Heathcote Road Upgrade, Infantry Parade to The Avenue

Addendum review of environmental factors

Roads and Maritime Services | September 2019

Figure 3-1: Key features of the proposed modification – map 1

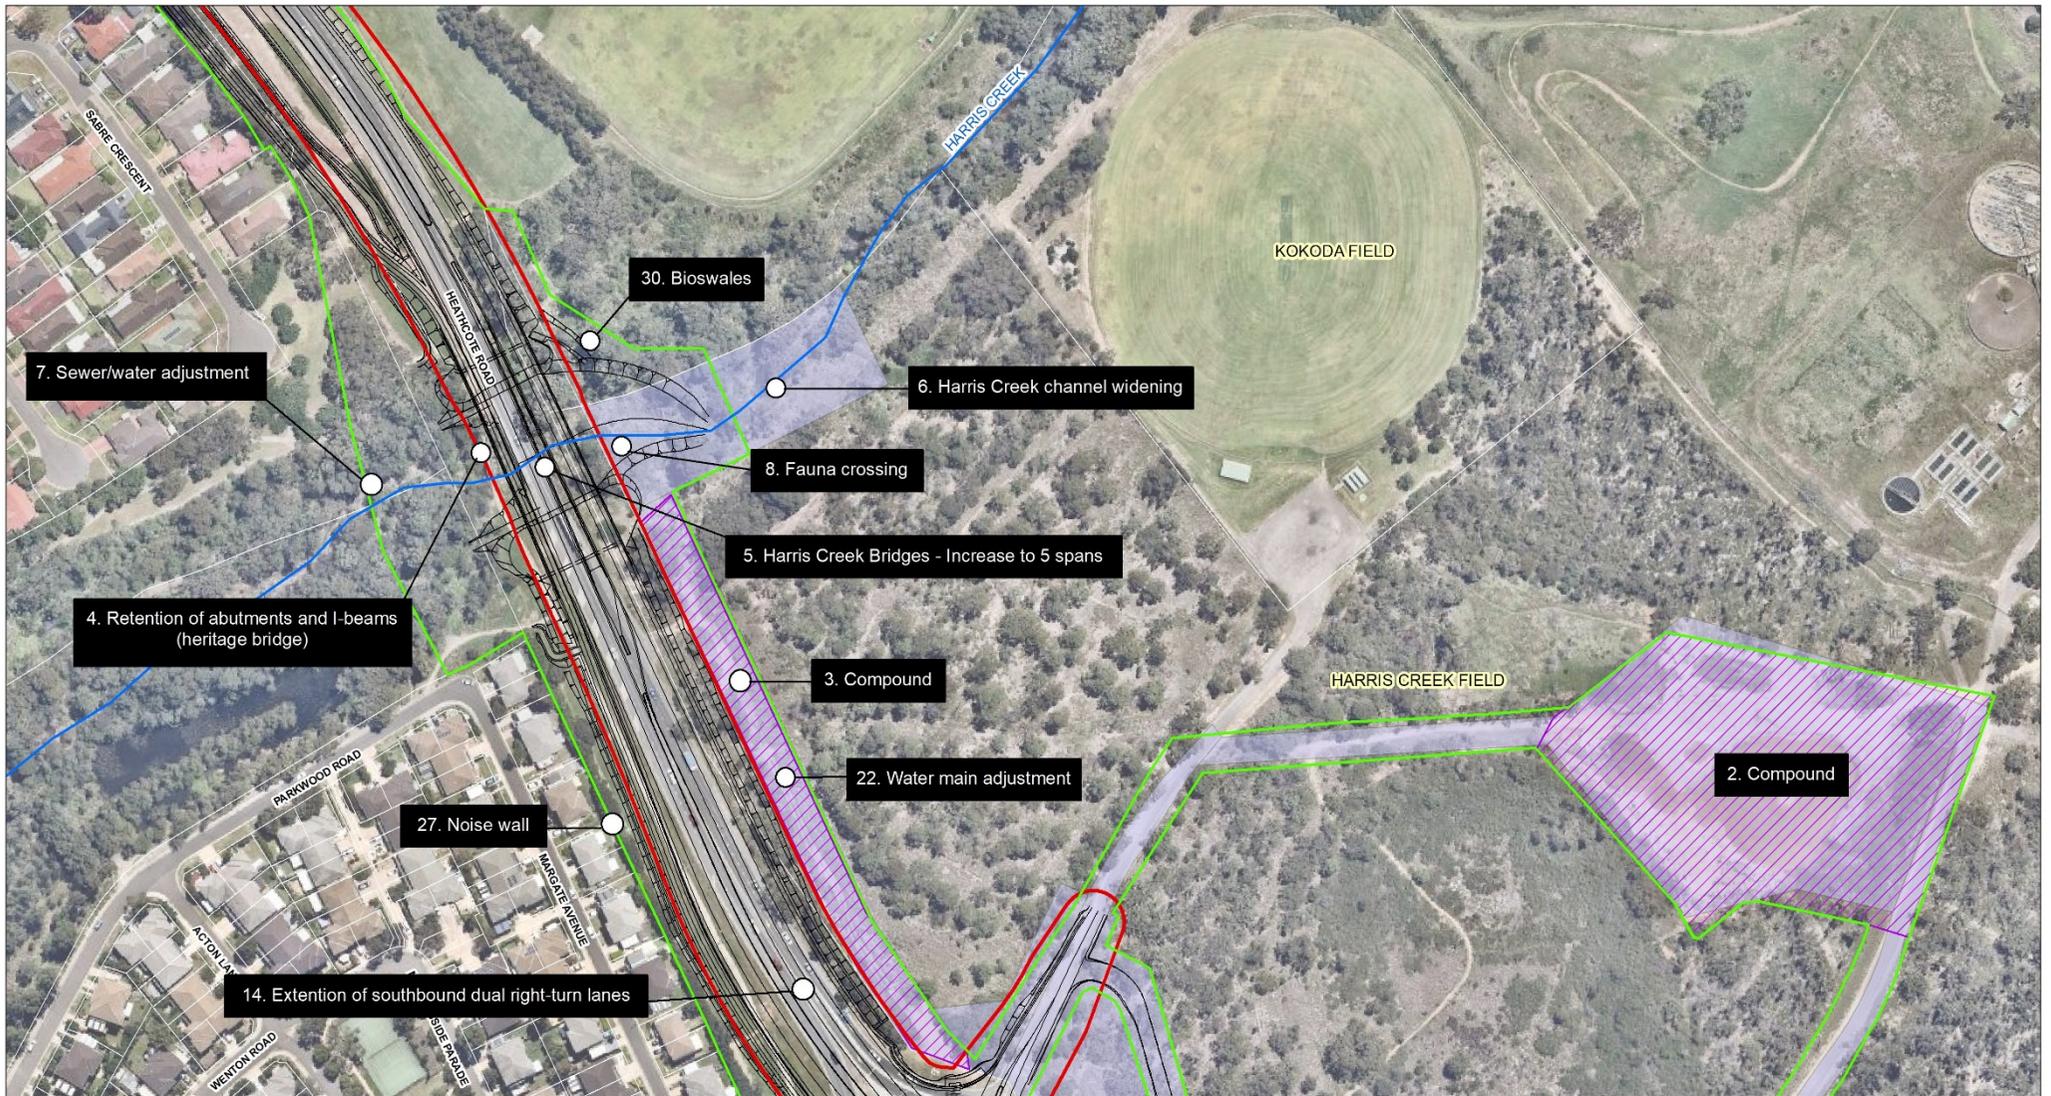
Various changes to the project boundary (also known as 'project area') are required to accommodate all elements of the detailed design including (refer also to Figure 3-1 to Figure 3-7 which shows the original and revised boundaries):

- Utility works within the rail corridor including power and communications. This also includes some trimming of vegetation near the Heathcote Road rail overbridge to meet minimum Ausgrid clearance requirements.
- Department of Defence watermain adjustment on the eastern side of Heathcote Road, north of Macarthur Avenue (refer to Figure 3-2 item 22).
- Underground power connections near Artillery Crescent (refer to Figure 3-1 item 20).

Figure 3-8: Harris Creek twin bridges – elevation of westbound bridge

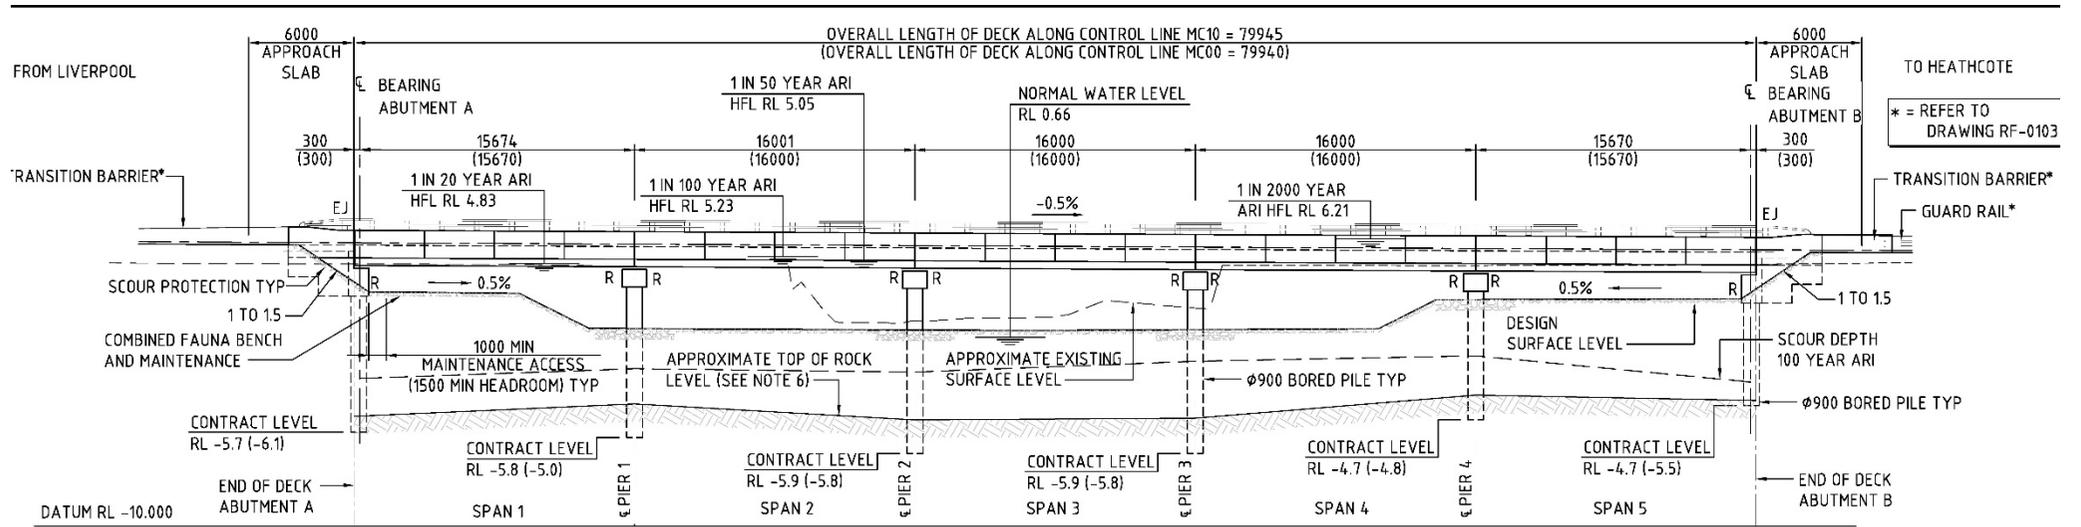
The proposed modification includes five span 80-metre-long twin bridges over Harris Creek. The key features of the proposed twin bridges are identified in Table 3-2.

Attribute	Project REF	Proposed modification
Length	60 metres	80 metres
Number of spans	3	5
Span length	30 metres	16 metres
Traffic lanes	3.5 metres	3.6 metres
Outside shoulders	1.5 metres	Minimum 1.5 metres

Figure 3-10: Harris Creek utility bridge – elevation

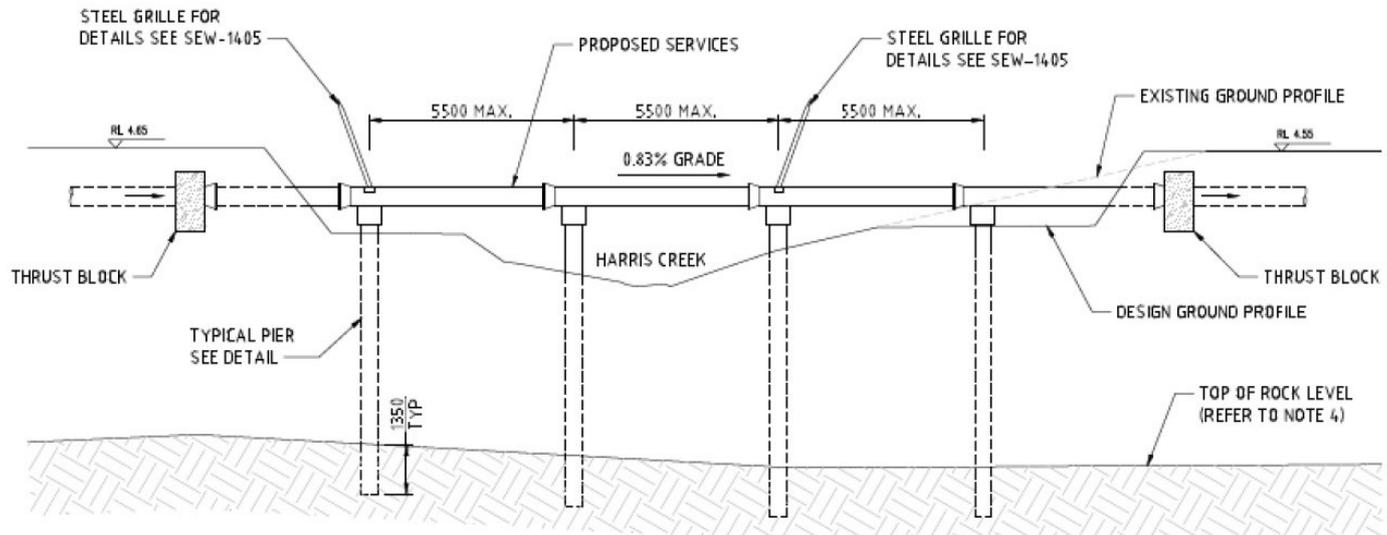
As part of the proposed modification a utility bridge is proposed about 20 metres upstream of the Harris Creek Pedestrian Bridge. The utility bridge would carry a 450-millimetre diameter sewer main, 350-millimetre water main and 150-millimetre water main. The utility bridge would have three spans about 5.5 metres wide and four 400-millimetre cast in place concrete piers with permanent steel casing. The key features of the utility bridge are shown by the elevation included in Figure 3-10.

Figure 3-11: Proposed configuration – Heathcote Road / Macarthur Drive intersection

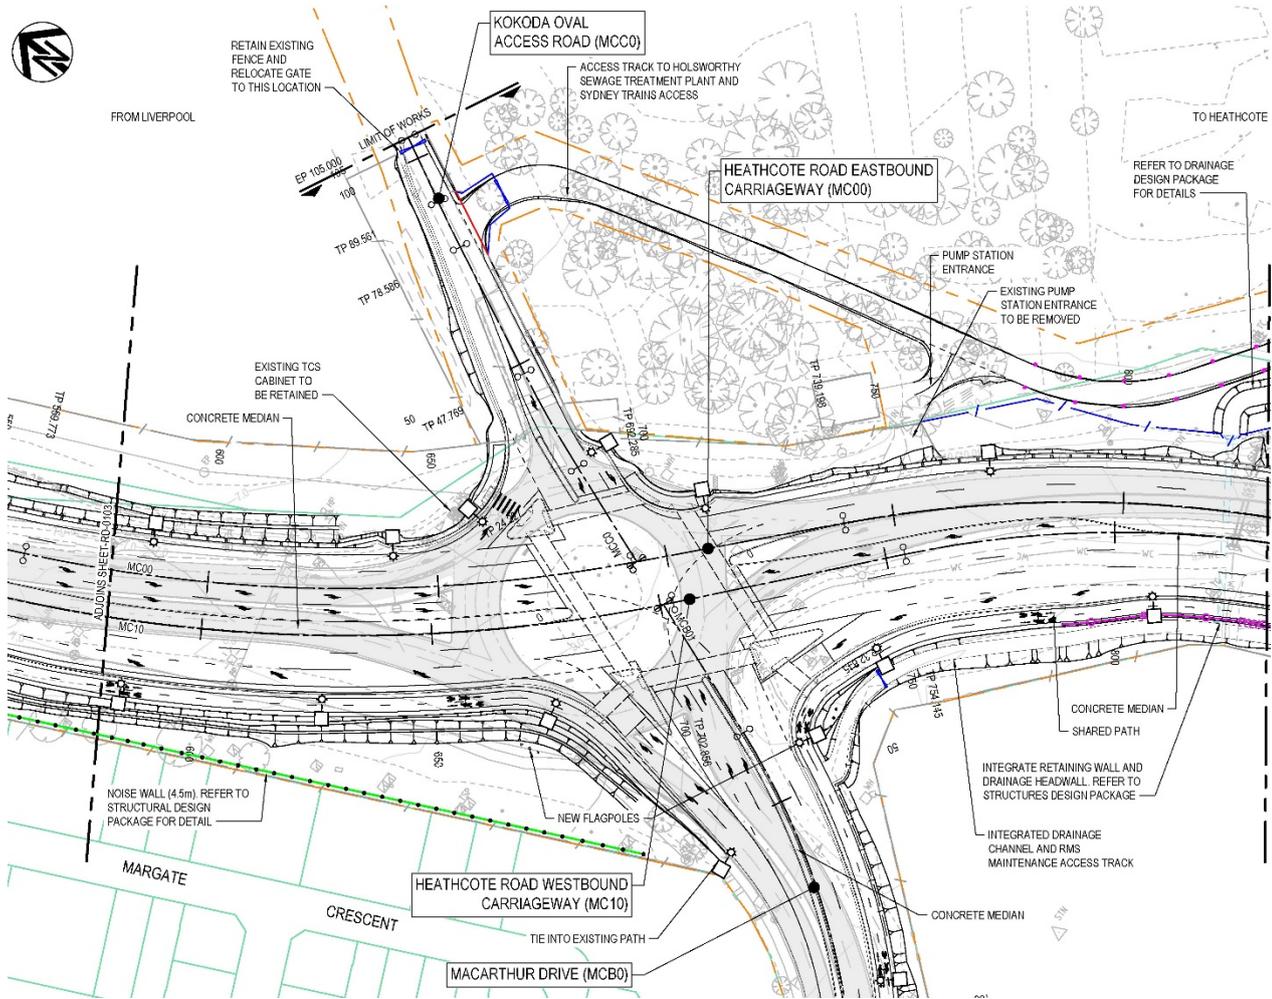
- Extension of southbound dual right turn lanes from Heathcote Road into Macarthur Drive by about 70 metres
- Addition of a third northbound lane between Macarthur Drive and the rail bridge
- Additional right-turn from The Avenue to Heathcote Road.

The first two changes are illustrated by Figure 3-11 and Figure 3-12, while the third change is shown by Figure 3-13.

Figure 3-17: Proposed noise wall changes – NCA A – typical cross section

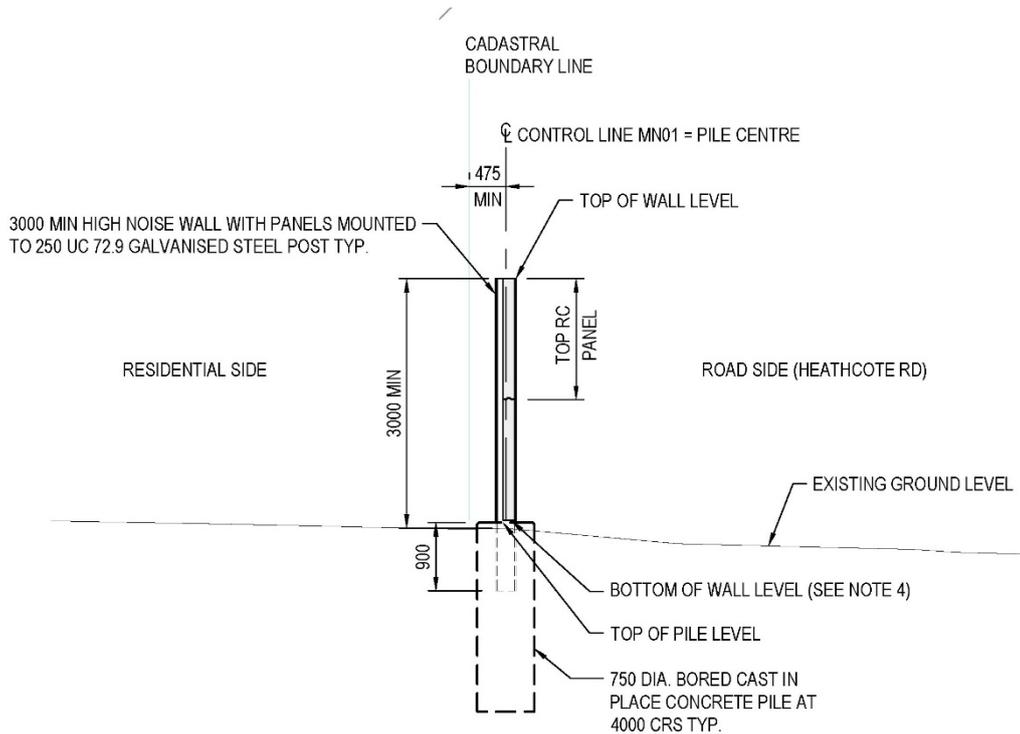
The location of the proposed noise wall changes is shown by Figure 3-15 and Figure 3-16 respectively, while cross sections for each wall are shown in Figure 3-17 and Figure 3-18.

Figure 6-3: 100 year ARI flood depth – with project

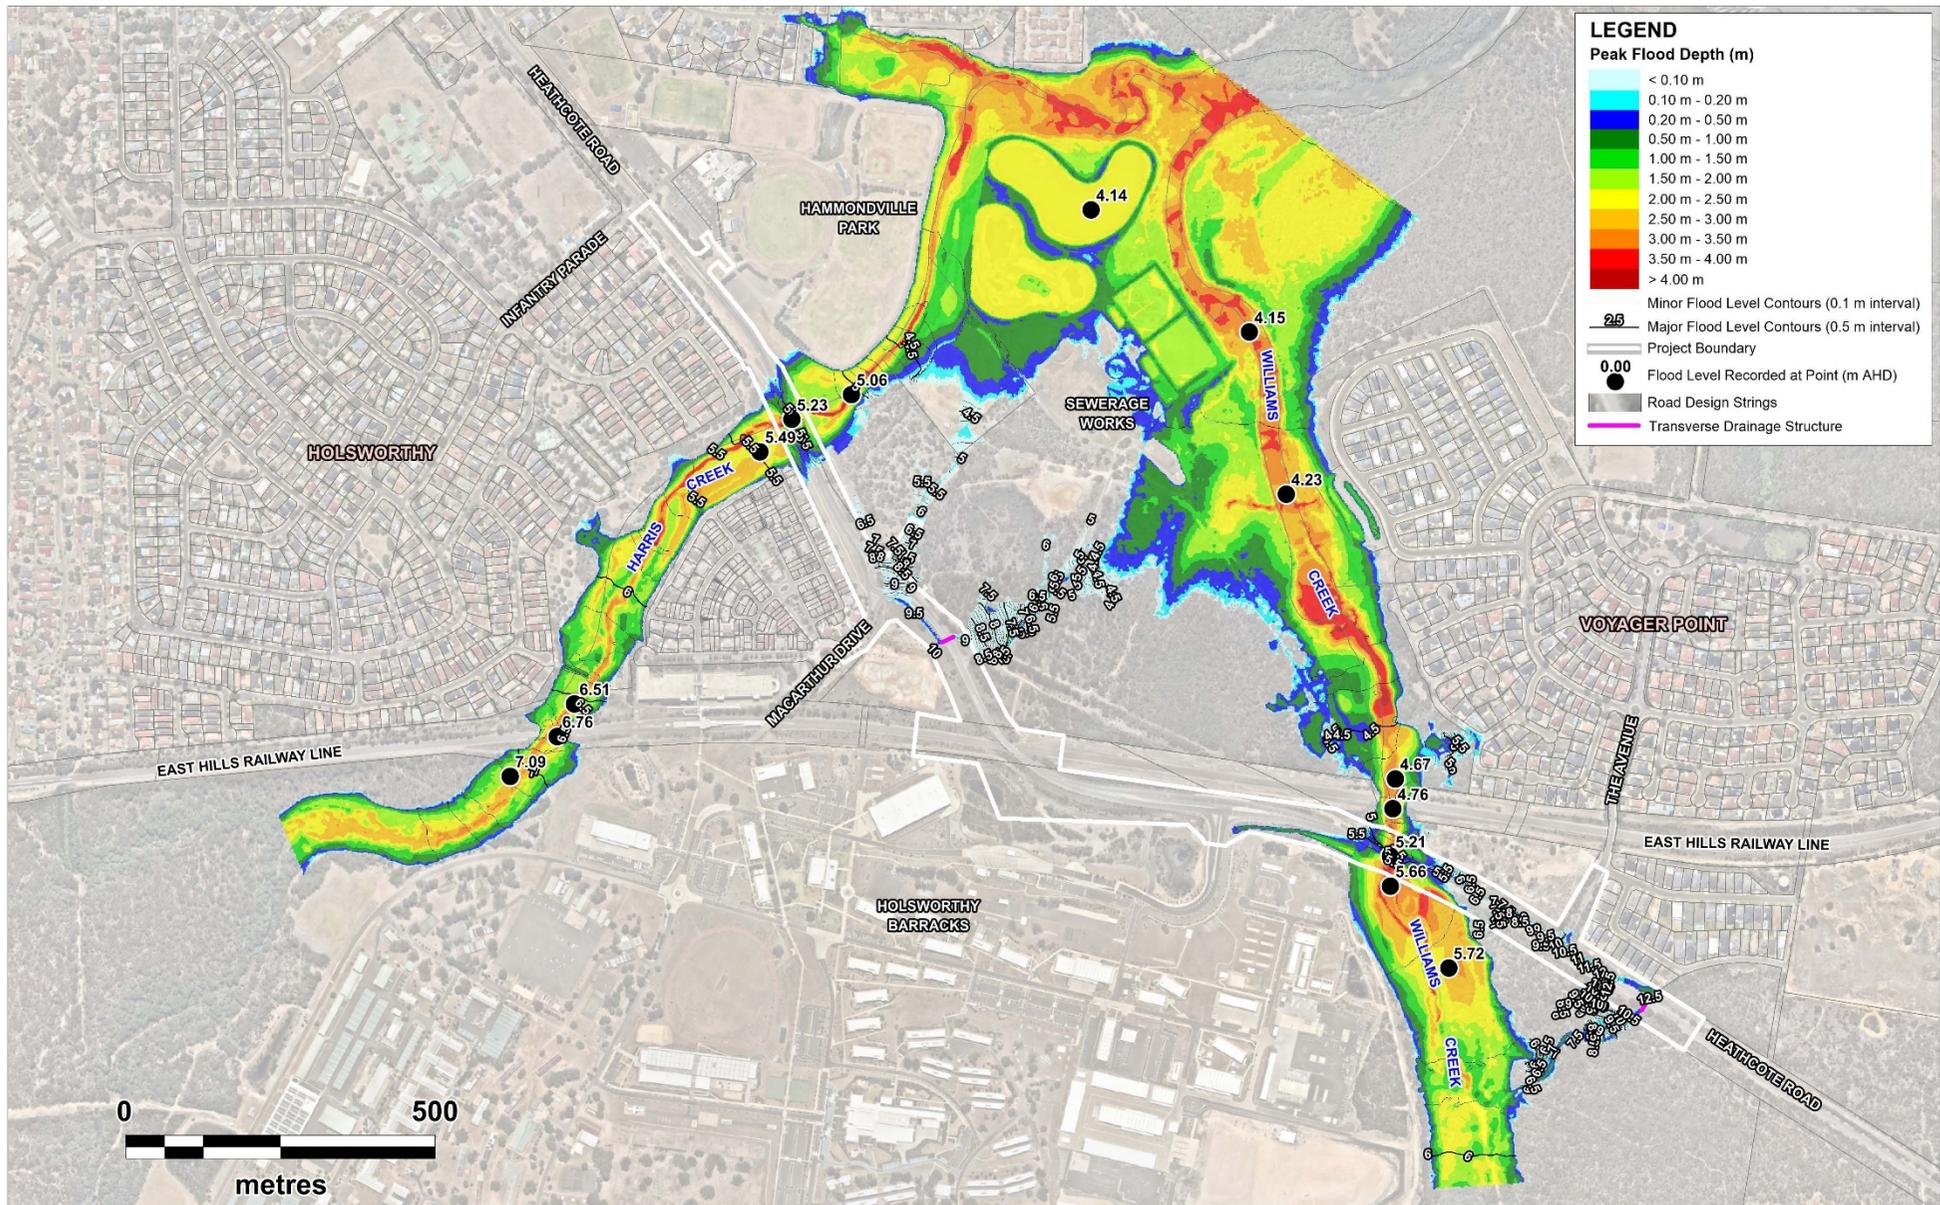
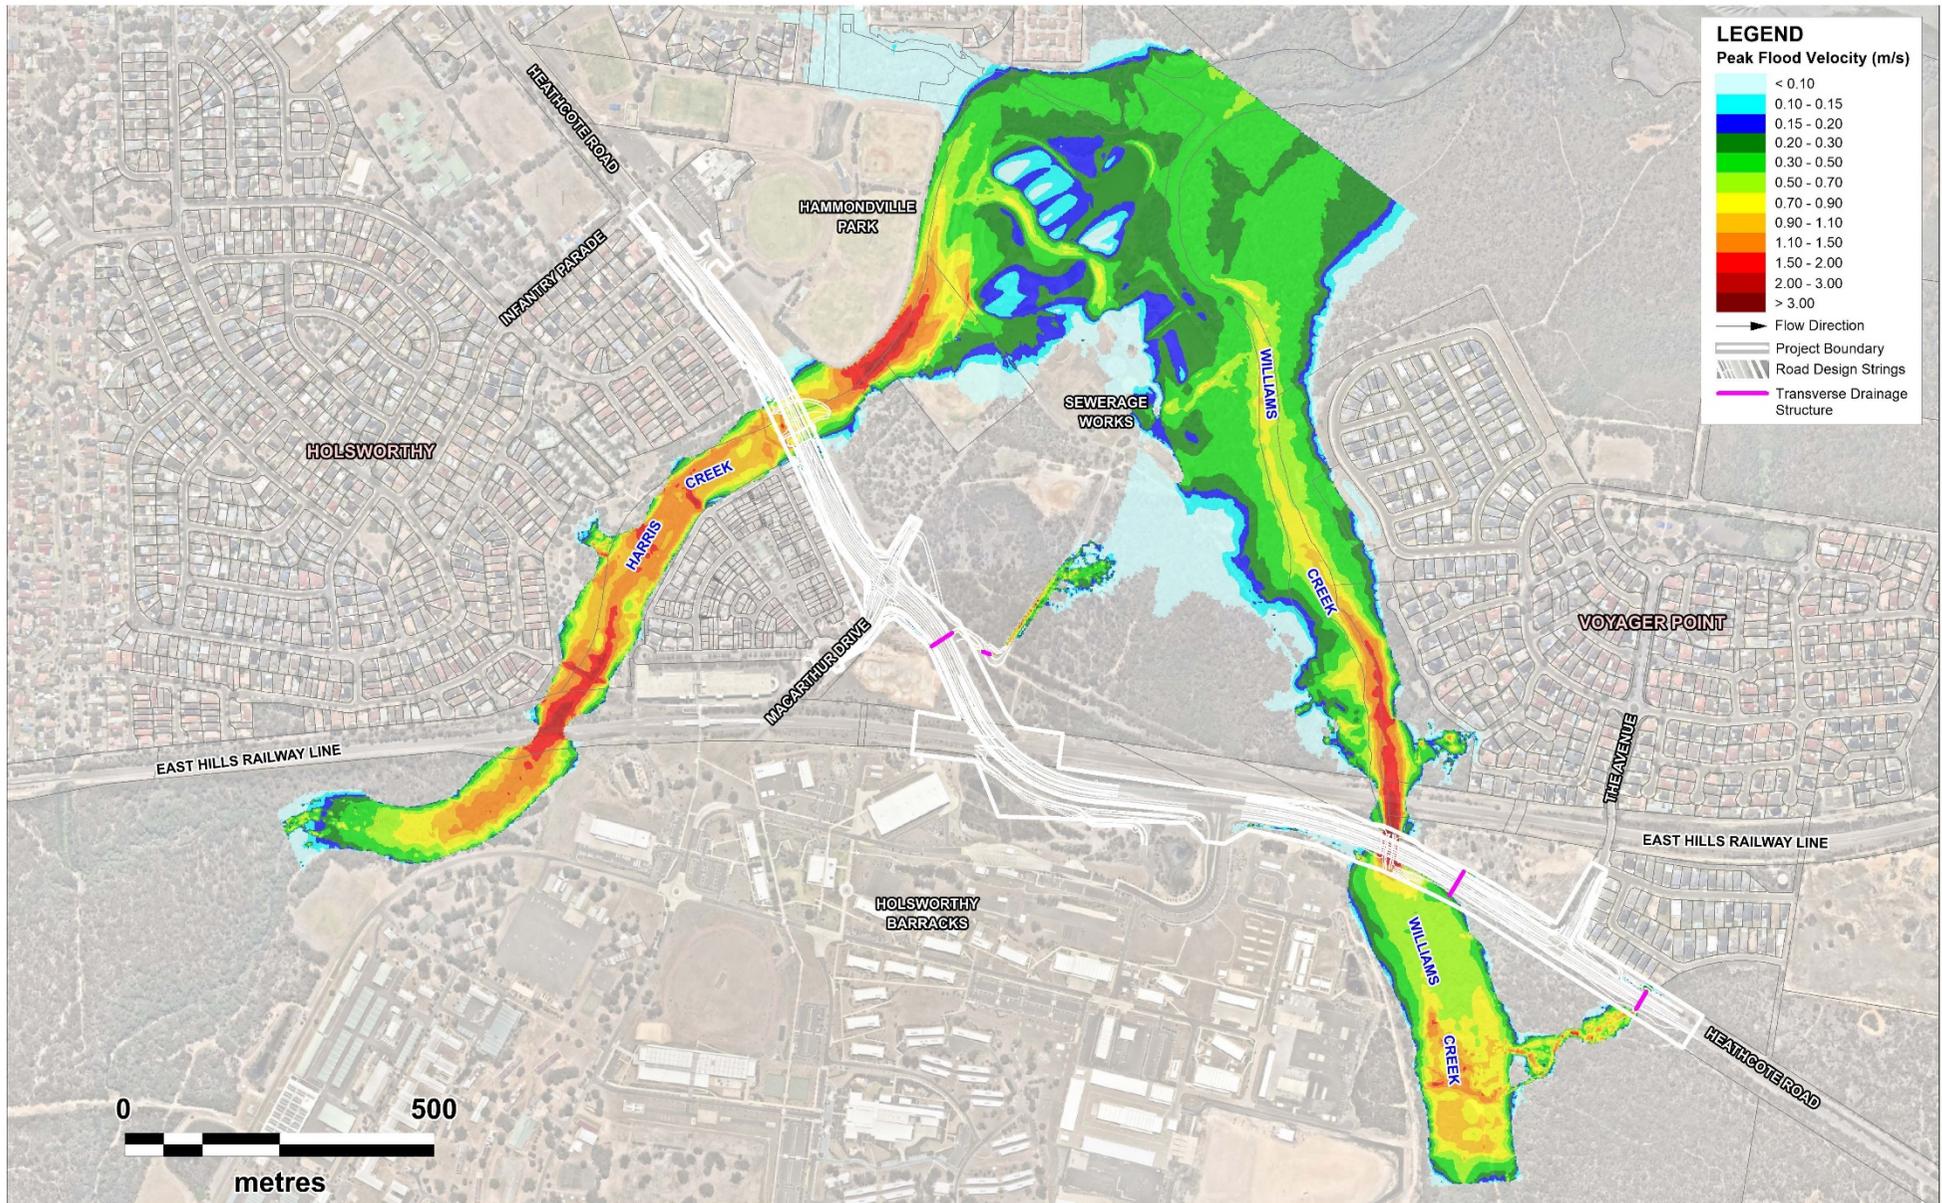
Flood modelling carried out as part of the detailed design process identified that there would be substantial flood level reductions upstream of Harris Creek and Williams Creek bridges as a result of larger bridge openings with higher soffit levels. Major velocity reductions were also noted near the Harris Creek bridge due to proposed channel widening.

Modelled flood extents and depths and for 100-year ARI for the existing situation and with the project (inclusive of the proposed modification) are shown by Figure 6-2 and Figure 6-3 respectively.
